p. 38 T5 description.

p. 15 Flow Chart.

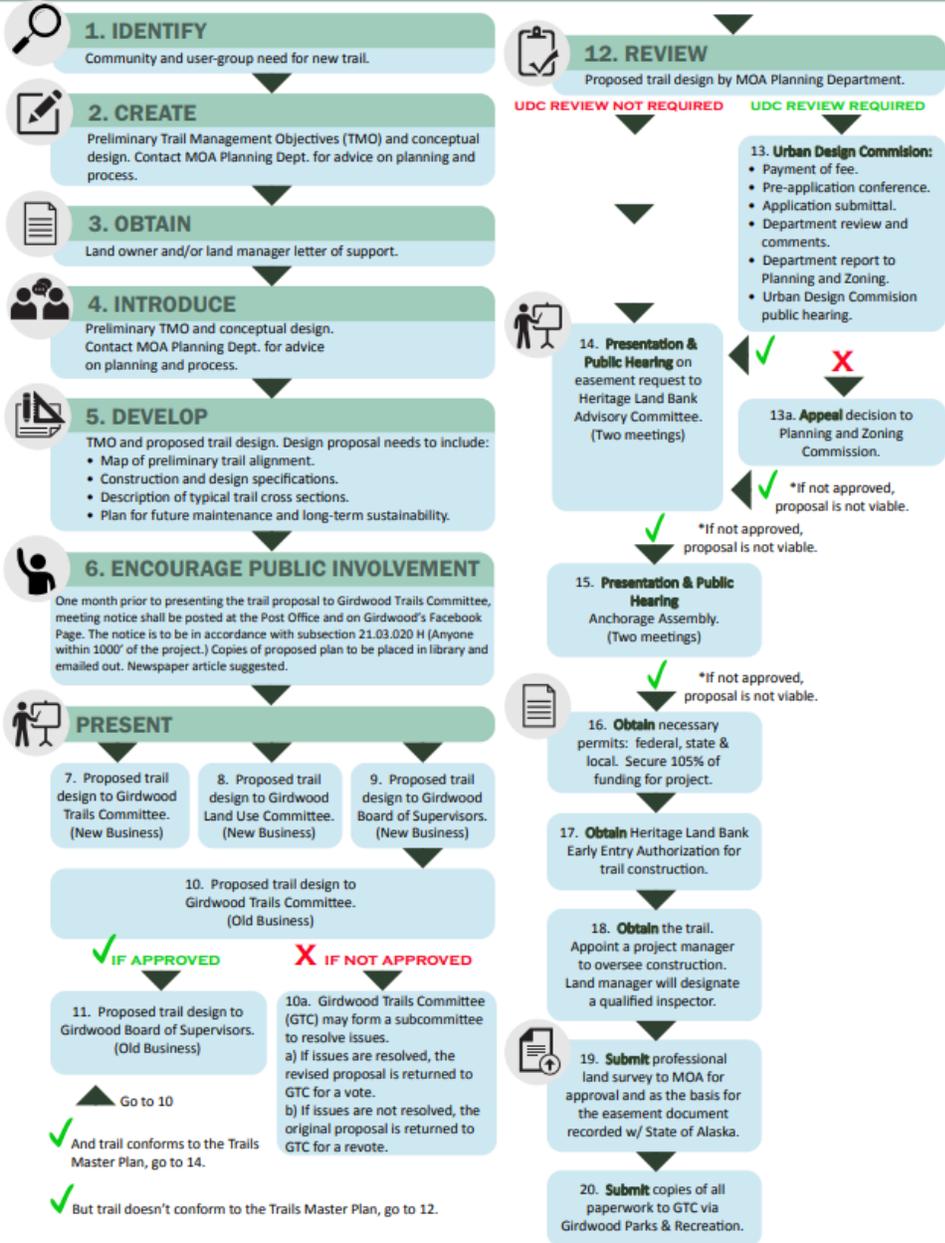
We discussed in GTC meetings that we wanted to change the Flow Chart so that GTC did not appear to be subordinate to LUC. In the blue line document, the Old Business section for LUC has simply been eliminated. I feel that people expressed quite clearly at the meetings that they thought it was important that a project get a second round of presentation at LUC just to increase the exposure to the project within the community. I have shared the revamped chart that I sent in my edits with the GTC and I think that chart is what people had agreed to.

Both charts are below. Motion regarding chart was withdrawn during amendment process, with requirement that the chart be re-worked to show process. Some changes have been made, including typos. However, Trails Plan 12.20.22 chart still needs to be revised to show:

LUC reviews as old business and provides vote that is also forwarded to GBOS.

GBOS considers both opinions of GTC and LUC and has a process to handle disagreeing opinions with LUC/GTC.

Language regarding newspaper outreach may be omitted.
